APPLICATION: DM/26/1597

PROPOSAL: RETROSPECTIVE APPLICATION TO RAISE LAND LEVELS TO CREATE A LEVELLED GARDEN AND INSTALL PATIO (UPDATED PLANS RECEIVED AND DESCRIPTION AGREED ON 11.09.2026)

SITE: 5 WILLIAM ALLEN LANE, LINDFIELD, HAYWARDS HEATH, WEST SUSSEX, RH16 2SA

Figure 1: Heights of the constituent parts of the land raising above ground level, in millimetres

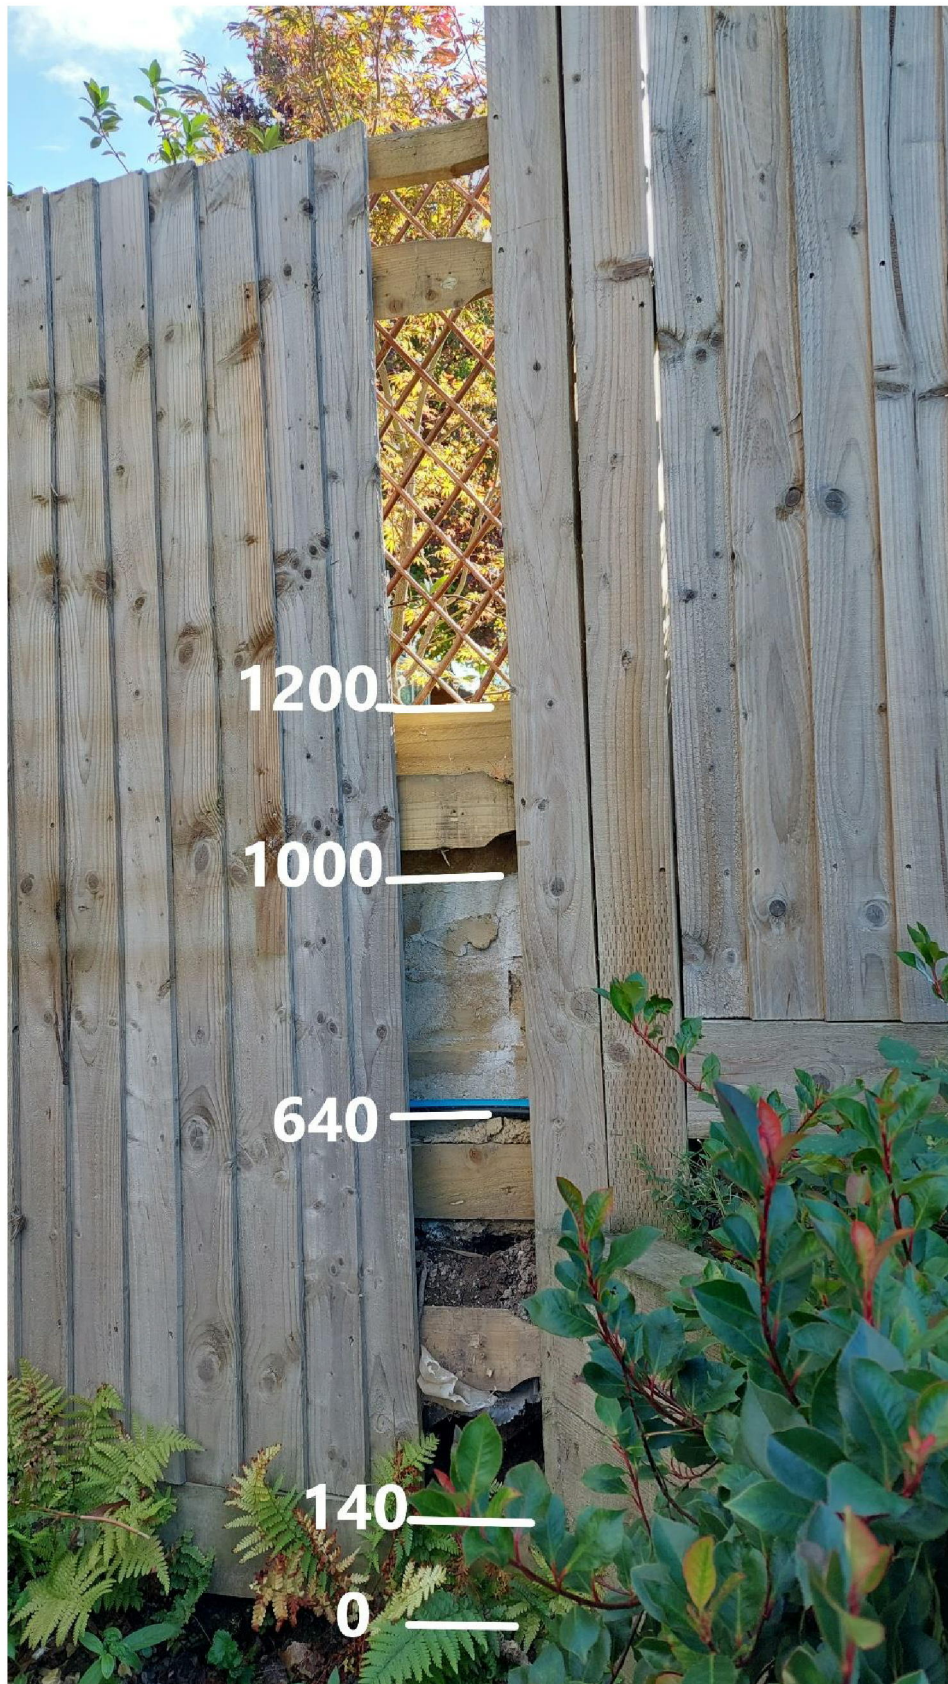
The removal of sections of fencing has exposed construction which was previously concealed and which is not adequately represented on the submitted section drawing. The photographs show soil and other material immediately behind the existing fence, together with timber boarding, concrete/mortar and the construction supporting the raised patio. Figure 1 shows the height above ground level of these constituent parts.

Figure 2 shows a worn piece of hardboard that has been wedged between the horizontal struts of my client's fence and the mix of soil and mortar that has been placed to fill the gap behind. This extends down to the very bottom of my client's fence, 1.2 metres *below* the level of the neighbour's new patio. The 1200mm measured does not correlate with the 640mm height increase shown on the submitted section plan.

Figures 3 and 4 show this horizontal timber board referred to in the report. The original fence supports are outlined in blue. The photograph shows that the upper timber board has been fixed to the *back* of the fence, and *below* the blue irrigation pipe (see Figure 1). This indicates that engineering operations have been undertaken at lower levels than indicated on the submitted section plan. Above the pipe there is a further 560mm of concrete, blockwork and patio pavers.

Figure 3: Original parts of the fence (outlined in blue) and the horizontal board that has been fixed to the back of the fence (red)

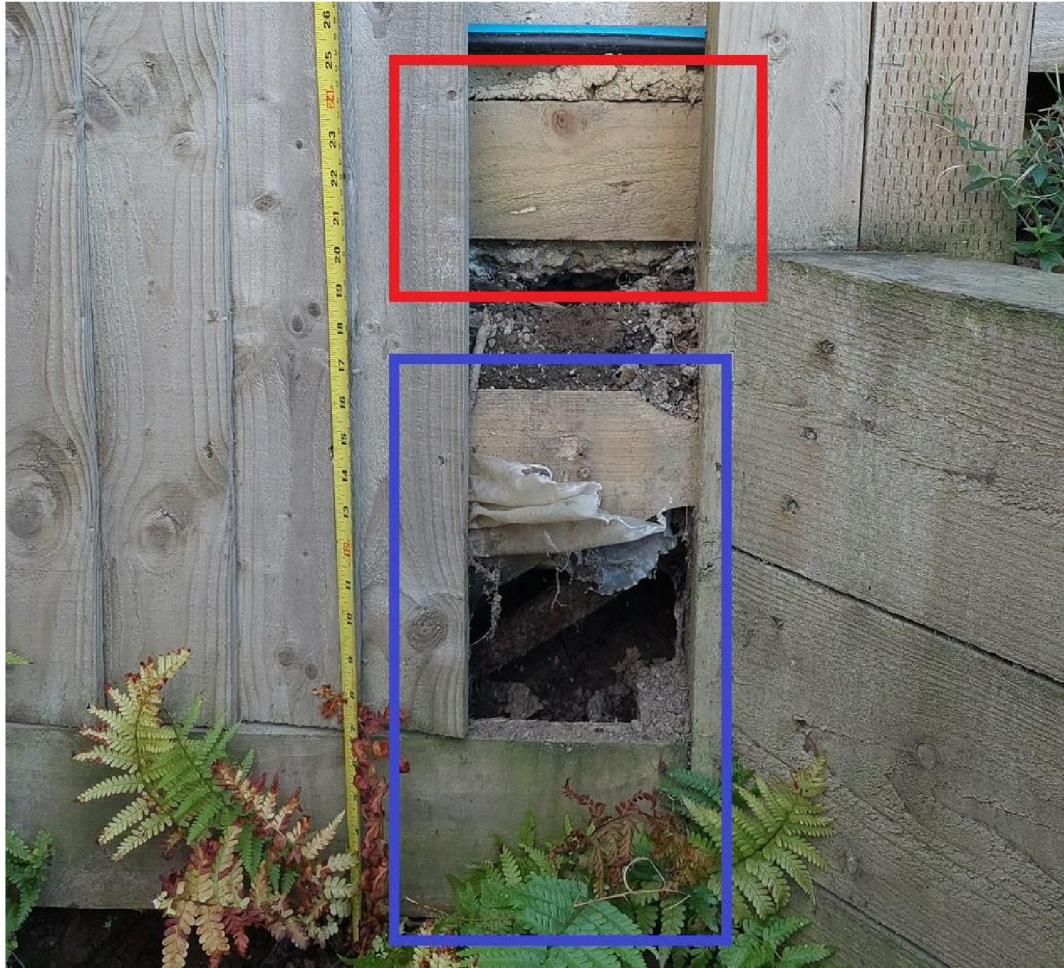
The Site Inspection Report states that parts of the lower retaining construction/footings appear to have been formed using timber boards approximately 100–125mm wide fixed against or between the existing fence posts, with concrete/mortar and block work constructed above.

Figure 4: View showing outdoor seating area, and proximity to the neighbour's raised patio

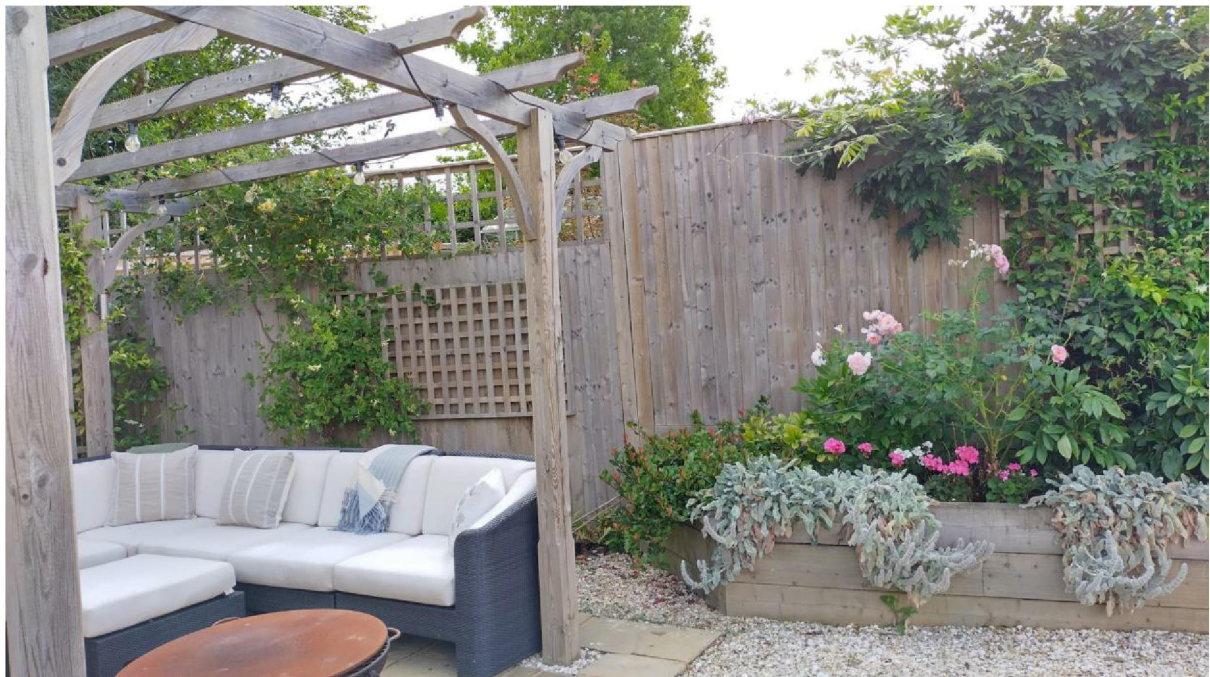
Also, my client has an outdoor seating area directly below the raised land, so it is not difficult to imagine how much the unobstructed overlooking by the neighbours adversely impacts on her enjoyment of her home.

Figure 5: Person visible above waist height

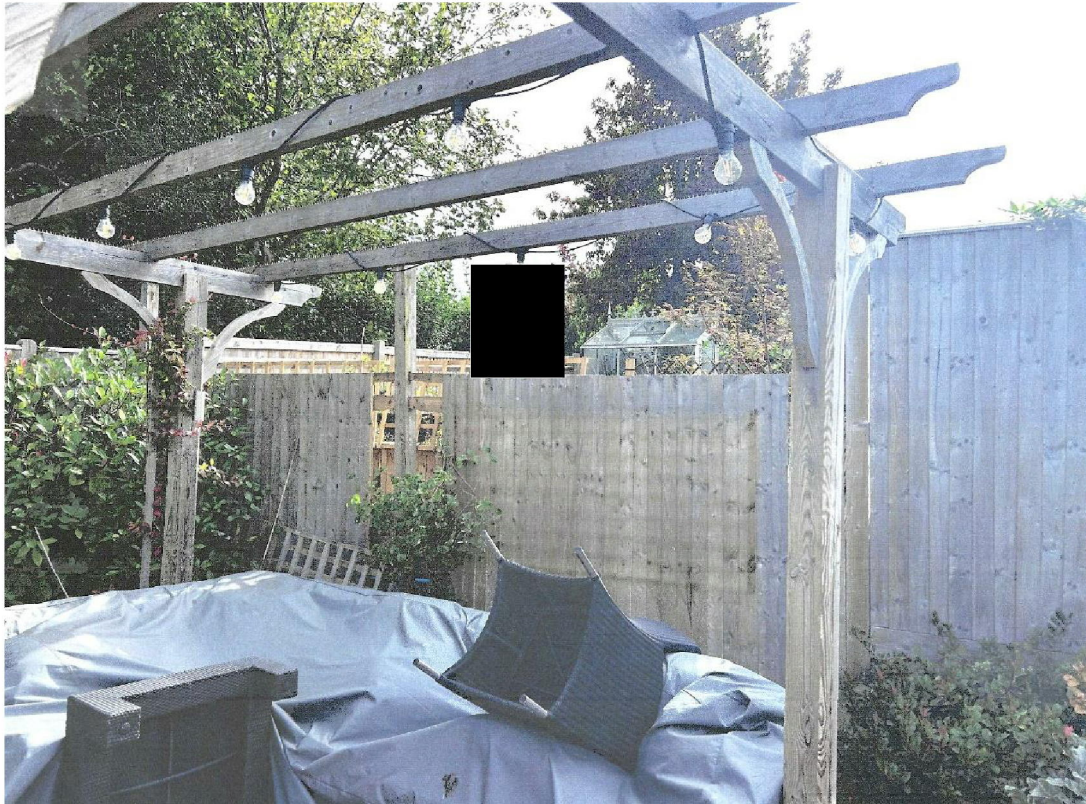
Figures 5 and 6 illustrate this. Someone standing on the neighbours' patio is now visible from the waist up, and this has a very damaging impact on my client's ability to quietly enjoy the her own home. She can no longer enjoy the privacy that one would expect in her rear garden as a result.

The photographs in Figures 5 and 6 are decisive and indisputable. Policy DP26 requires that new development must not cause significant harm to the amenities of existing nearby residents and future occupants of new dwellings, including taking account of the impact on privacy. The engineering operations to raise the level of the garden have caused significant harm to my client's privacy as they allow for direct, unrestricted views into her private outdoor space. These are not mere glimpses from a distance but a close up, direct and unobstructed view into her private garden. There is nothing to prevent the neighbour from looking directly over her fence into her garden *and* through the patio doors into her living room at any time of the day or night.
